COMMITTEE OF ADJUSTMENT

NOTICE OF PUBLIC HEARING **Minor Variance**

APPLICATION NO.: HM/A-20:229

SUBJECT PROPERTY: Municipal address **412 Dundurn Street, Hamilton**

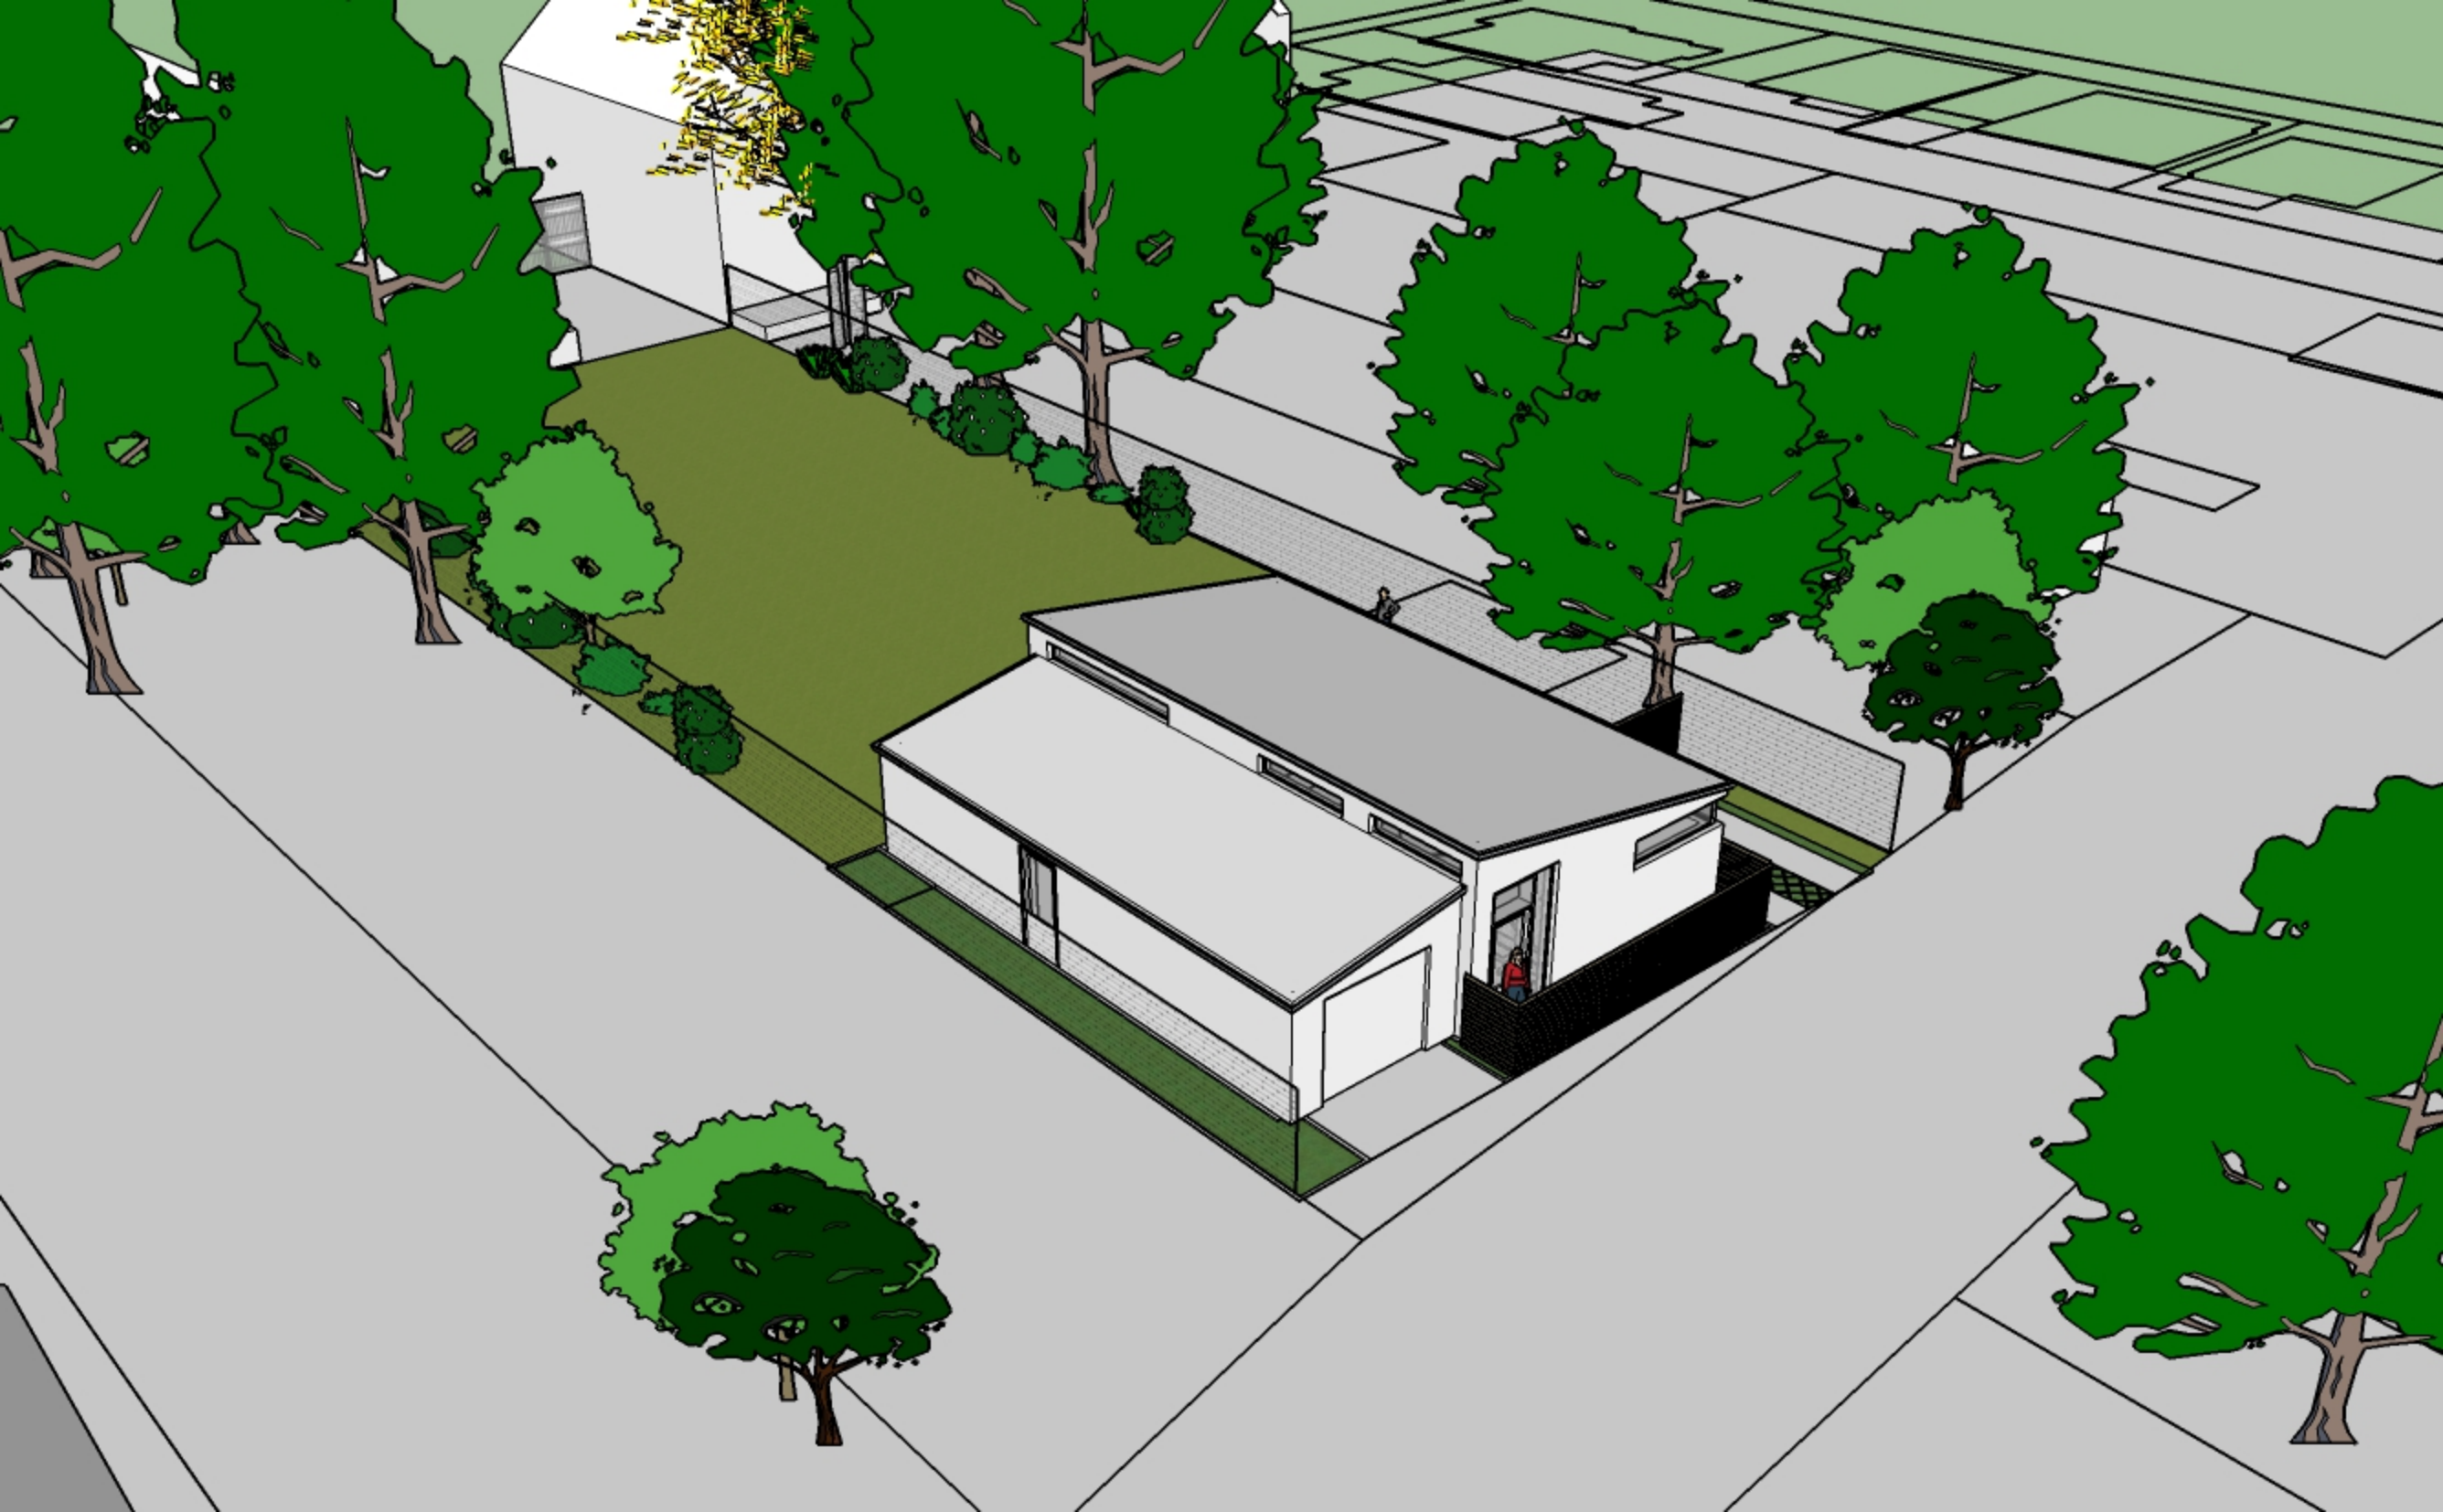
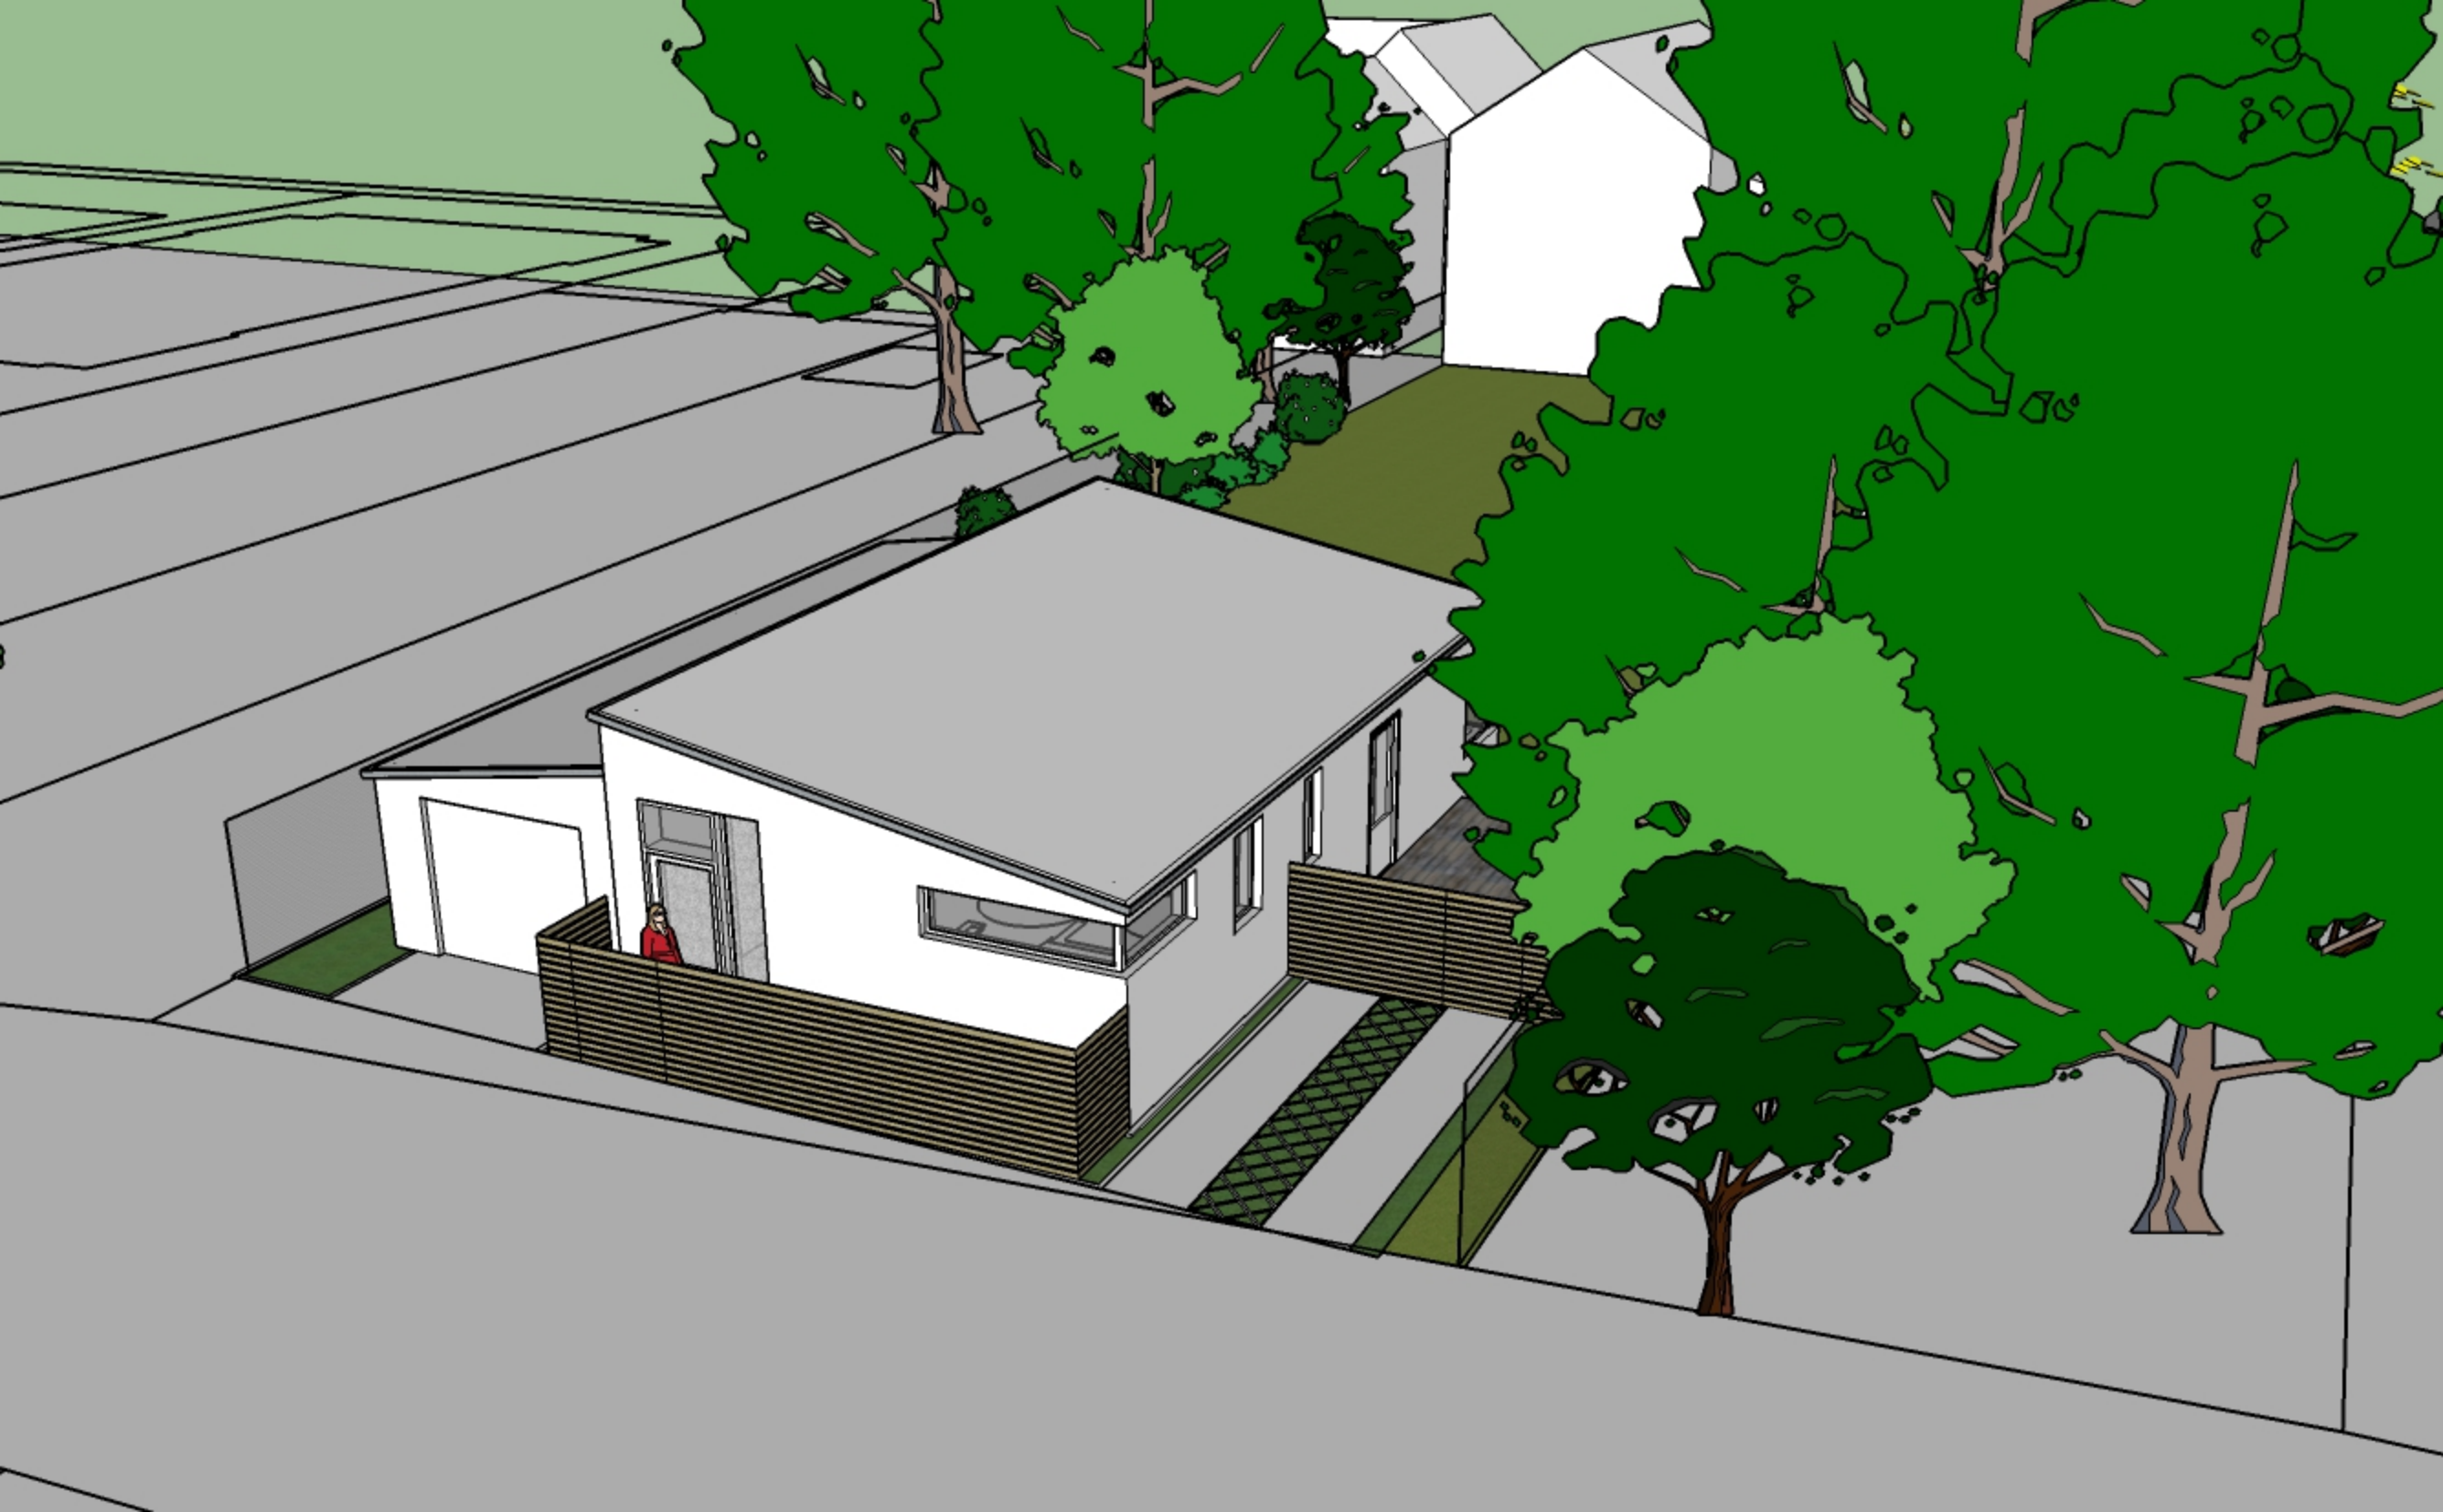
1. The minimum landscaped area to be provided in the rear yard was not indicated on the submitted site plan to confirm zoning compliance. Please note that an email provided by the applicant on August 3, 2021, confirmed that the landscaped area in the rear yard is to be greater than the required 12.0 square metres. Additional variance(s) may be required if compliance with Section 19(1)(xix) is not possible.

2. Please note that the distance the eaves/gutters encroach into a required yard was not indicated on the submitted site plan to confirm zoning compliance. Please note that an email provided by the applicant on August 3, 2021, confirmed that the eaves/gutters will not encroach more than the permitted 0.45 metres. Additional variance(s) may be required if compliance with Section 19(1)(1)(ii)(1) is not possible.

3. Please note that as per Section 19(1)(1)(ii)(6), a minimum setback from a Swale, Ditch or Drainage Management System measured from the upper most interior edge of the swale's slope of 1.0 metres shall be provided and maintained. Insufficient information has been provided to determine zoning compliance. Additional variances may be required if compliance with Section 19(1)(1)(ii)(6) is not possible.

4. Please note that as per Section 18(3)(vi)(e), a terrace may project into a required yard, if distant at least 0.5 metres from the nearest side lot line. The submitted site plan indicates a terrace is proposed in the southerly side yard abutting the secondary dwelling unit – detached, that extends to the southerly side lot line. Please note that an email provided by the applicant on August 3, 2021, confirmed that the terrace will be reduced in size and will be distant at least 0.5 metres from the southerly side lot line. Additional variance(s) may be required if compliance with Section 18(3)(vi)(e), is not possible

5. Please note that the specific dimensions of all proposed parking spaces and the width of the driveway(s) have not been indicated to confirm zoning compliance. Additional variance(s) may be required if compliance with Section 18A(7) and Section 18A(24)(a) is not possible.
